**STATE OF CALIFORNIA  
REGIONAL WATER QUALITY CONTROL BOARD  
CENTRAL COAST REGION**

**STAFF REPORT FOR REGULAR MEETING OF JULY 14, 2011**

**SUBJECT:** **Waste Discharge Requirements for the Olin Aquifer Containment and Cleanup System, Santa Clara County (Order No. R3-2011-0209)**

Calculating anticipated increase in nitrate in Tennant Well:

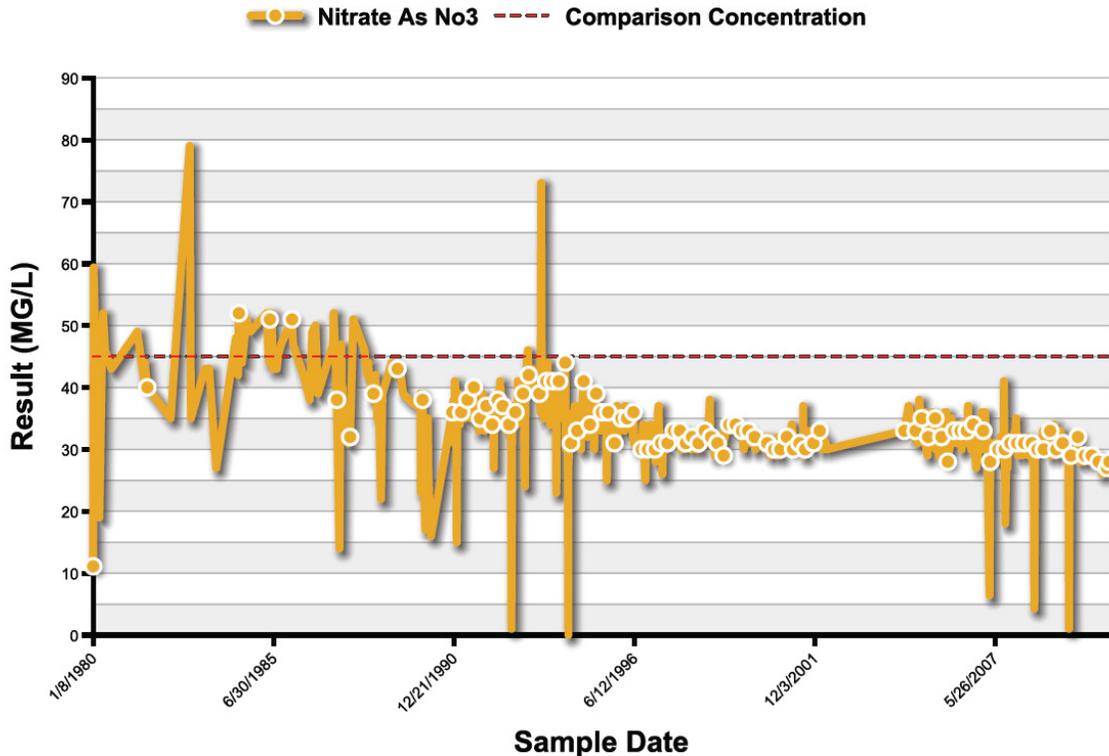
**3) General Comment from Olin regarding Impact of Reinjection on Tennant Well and in response to comments in draft WDR on Page 7, finding 15, tenth sentence; Page 9, finding 22, second paragraph; and Page 14, Ordering Paragraph B, point #2 (graph) –** *In the Draft WDR, the Water Board estimates that at the proposed quarterly and monthly nitrate discharge limits, on-Site reinjection of treated groundwater may have the potential to increase nitrate concentrations by up to 2 mg/L as nitrate. As noted in the attached comments, the method used to calculate the percent increase is incorrect and overestimates the potential effect of recharge on the nitrate concentration at the Tennant Well (which Olin earlier replaced by paying the cost of installing the higher capacity San Pedro Well in 2005). Applying the correct mathematical formula (described in the attached comments), the potential impact of on-Site reinjection on nitrate concentrations in the Tennant Well is estimated to be less than 0.5 mg/L, which is negligible compared to the temporal and spatial fluctuations of nitrate concentrations in the Llagas Subbasin.*

**Staff's Response:** Staff used conservative assumptions and calculations to estimate the nitrate increase in the Tennant Well. Staff "rounded up" the calculated nitrate increase in the Tennant well to 2 mg/L (see detailed calculation below). So, our conservative estimate is that nitrate in the Tennant Well will potentially increase from its current concentration of approximately 28 mg/L to 30 mg/L nitrate, which is within the temporal fluctuations (e.g., changes in nitrate concentrations due to seasonal changes in water table fluctuations, changes in spatial distribution of nitrate in groundwater, accuracy and precision of analytical analysis, etc.) of nitrate in the Tennant Well. Regardless, Olin's monitoring of nitrate concentrations in the shallow, intermediate, and deep aquifers in the vicinity of the Tennant Well will have sufficient spatial and temporal density to verify that actual nitrate concentrations are not different than the predicted changes of nitrate within each aquifer. Based on the concerns expressed in comments from other stakeholders, staff plans to modify MRP No. R3-2008-0028 before ACS startup (ACS startup scheduled for spring 2012) to ensure sufficient nitrate monitoring locations and frequency.

Representative source area of perchlorate in shallow aquifer: ..... 120 µg/L  
 Representative perchlorate concentration in the Tennant Well: ..... 6 µg/L  
 Resultant dilution factor:.....120/6 = 20  
 Dilution factor used in the calculation for nitrate: .....20 x ½ = 10

Current average concentration of nitrate in the shallow aquifer:.....24 mg/L  
 Estimated maximum long-term nitrate discharge concentration: .....38 mg/L  
 Resultant maximum shallow aquifer nitrate concentrations (100% discharge): .....38 mg/L  
 Change in shallow aquifer nitrate concentration over 10 years:..... 38-24 = 14 mg/L  
 Resultant change in Tennant Well concentration: ..... 14/10 (dilution factor) = 1.4 mg/L  
 Rounded up to the nearest integer:..... **2 mg/L**
